RE: BC-12 Diversion Modification (March 31, 1987), Utah Fuel Company, Skyline Mine, ACT/007/005, Carbon County, Utah

## Summary

Fig. 4-18. Inlet control nomograph for corrugated steel pipe culverts. The manufacturers recommend keeping HW/D to a maximum of 1.5 and preferably to no more than 1.0.

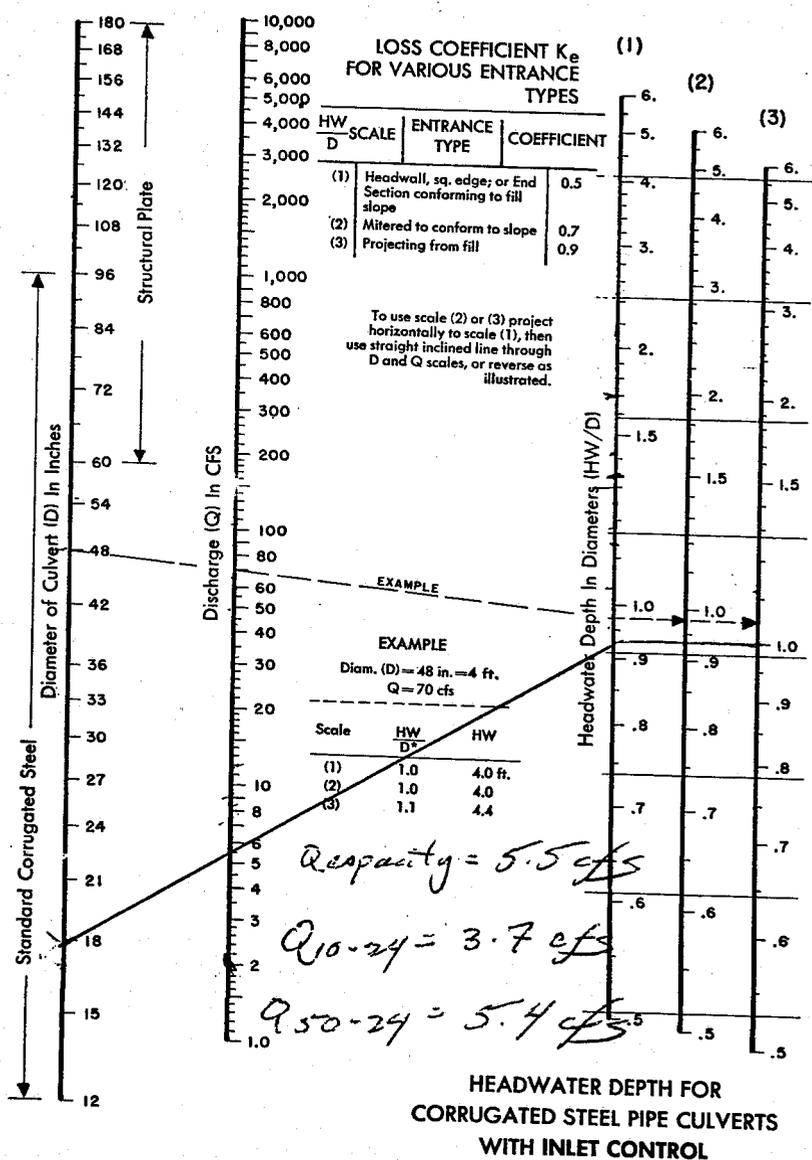
The expected peak flow for the drainage from the area reporting to diversion BC-12 was analyzed and found to be 3.7 cfs for the 10-yr, 24-hr event and 5.44 cfs for the 50-yr, 24-hr event. Applicant values differ from the Division's calculations due to methodology and assumption differences, but the existing 18 inch CMP was shown to have a capacity that exceeded the peak for the 50-yr, 24-hr event (capacity is at least 5.5 cfs). Wash down water is expected to be less than 50 gpm (0.111 cfs). Attached to this memo are the peak flow assumptions and calculations and the nomograph depicting the culvert capacity.

Division BC-12
